APPENDIX B

Responses to NRC Requests for Additional Information (RAI) Air Quality

Figure 1: 10-Year Monthly Temperature Comparison

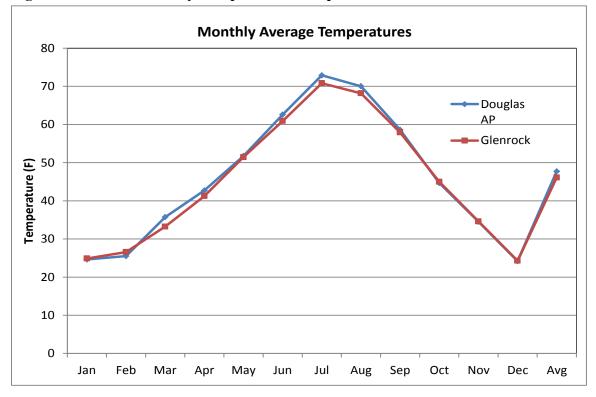
- A. Please confirm that the 2005 and 2007 data described in Section 3.6.1 are the best available data to characterize the meteorological conditions at the Ludeman Project or update the data with the most current information. Also, please include a map identifying the locations of monitoring stations relative to the Project area.
- B. Newcastle is listed in Table 3.6-1 of the ER as one of the meteorological stations included in the climate-change analysis. Please address the absence of data for Newcastle in the text and subsequent figures.

The period of record presented in the ER was based on available data at the time that it was originally developed. While the long-term regional climatic conditions tend to remain relatively stable over time, the tables and figures below have been revised to reflect the most recent meteorological data available.
